Minutes of the Technical
Committee Meeting held on 31-3-2000

Sr. No. 7/ITEM No-24/2000/T.C

SUB: Permissibility of nursing homes guest house and banks in residential use zone of rehabilitation colonies - proposed amendment in MPD-2001.
F.10(5)81-MP- Pt.II

ALTERNATIVE-II

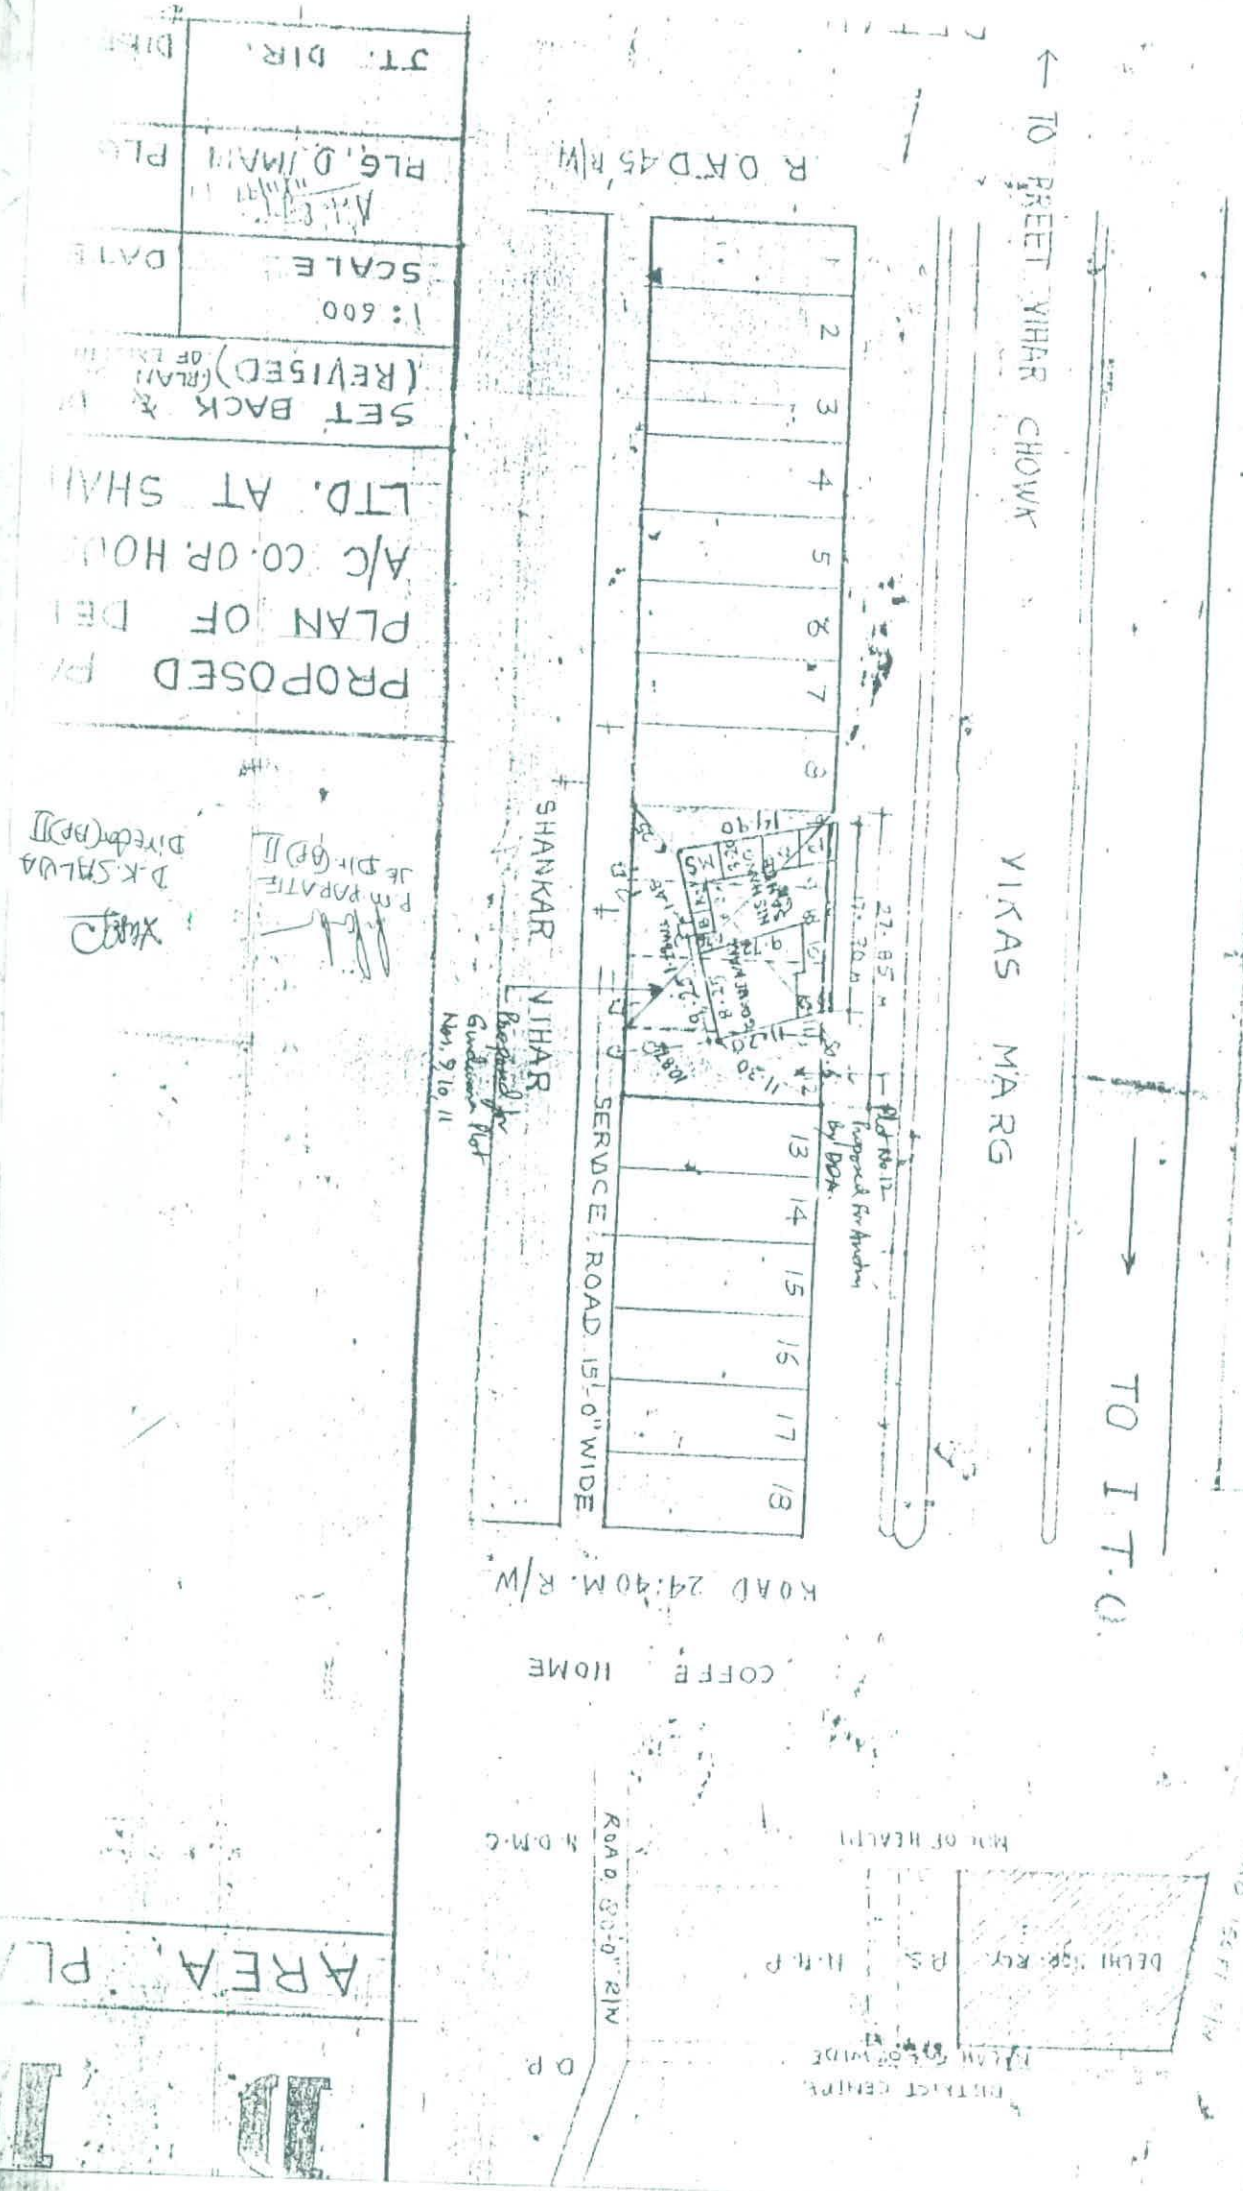
Since the Gurudwara is existing on 4 plot prior to the allotment of land to Society, it is suggested that it may be regularised on 3 plots only^(9 10 11) with an area of 382.75 Sq M. (being nearer to the standard of religious site i.e. 400 sq.mt. as per MPD-2001) and one residential plot¹² can be carved out which can be auctioned by DDA. Gurudwara will have to be adjusted in 3 plots instead of 4, retaining the position of Nishan Sahib as it is and one plot to be made available shall be auctioned by DDA.
